Category: **SN3500 INSTALLATION DRAWING**

Title: **KCS-55 REMOVAL (REF)**

Size B Document Number: **82005-10** Rev **A1**

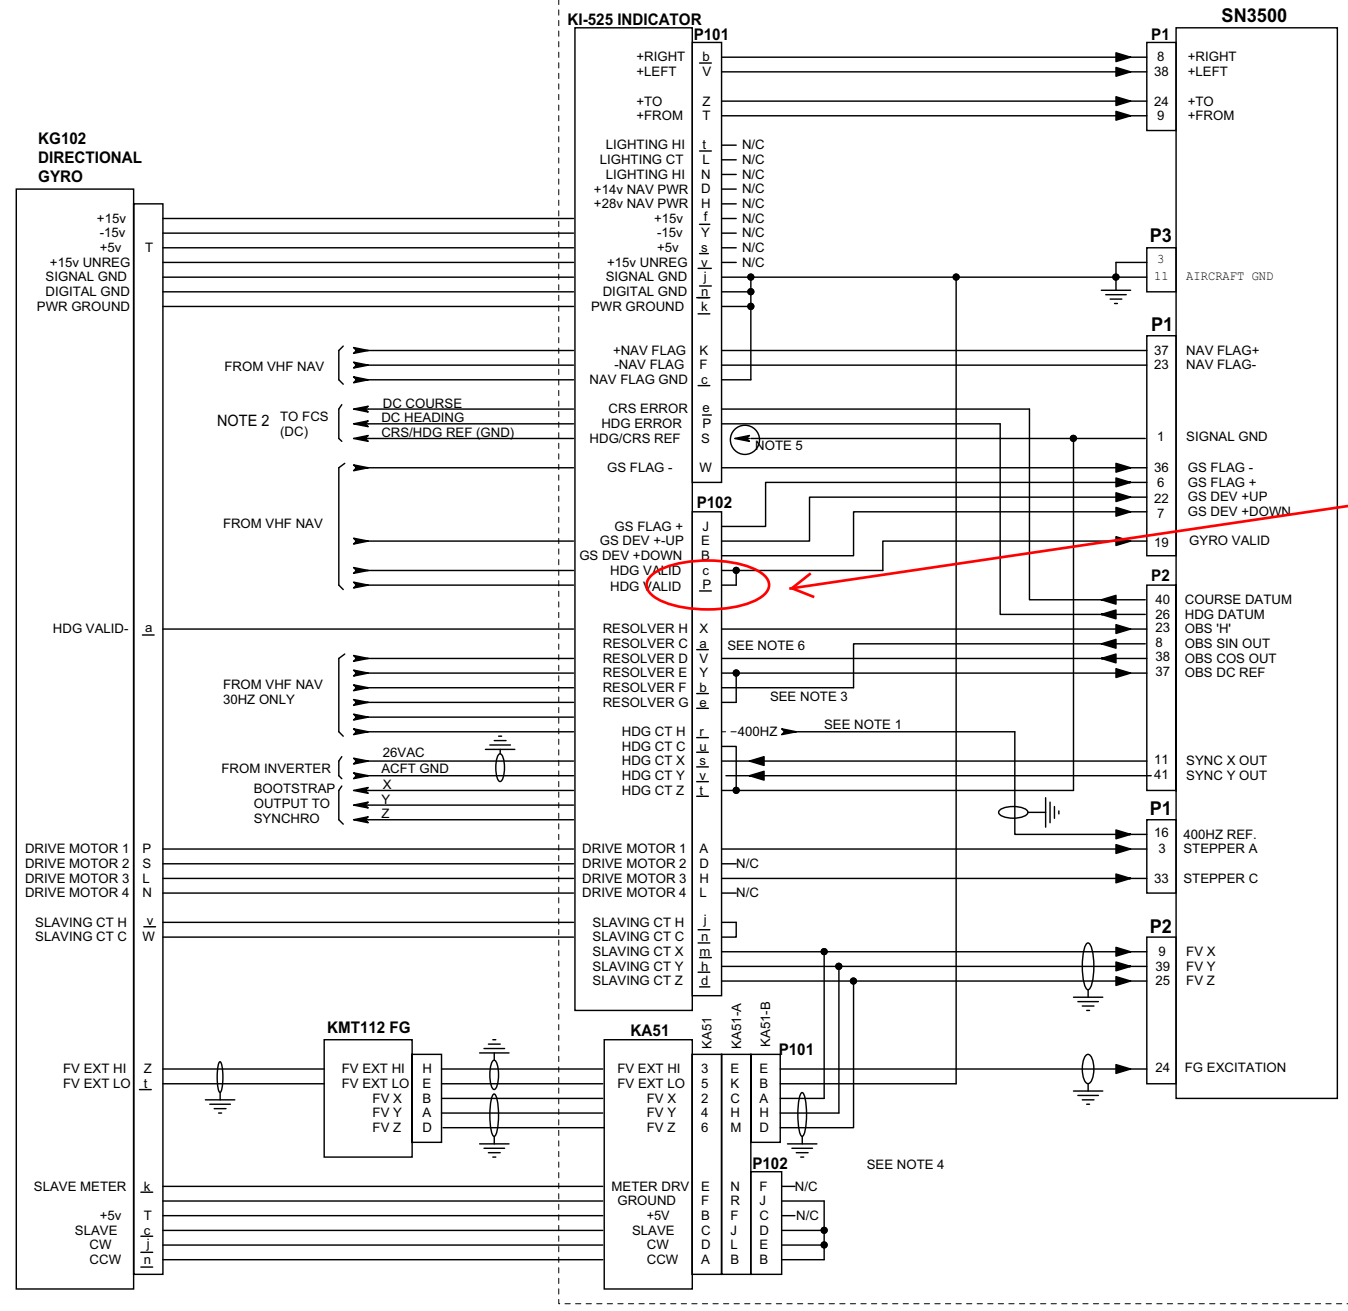
The underline (denoting lowercase) should be under c and not under P.
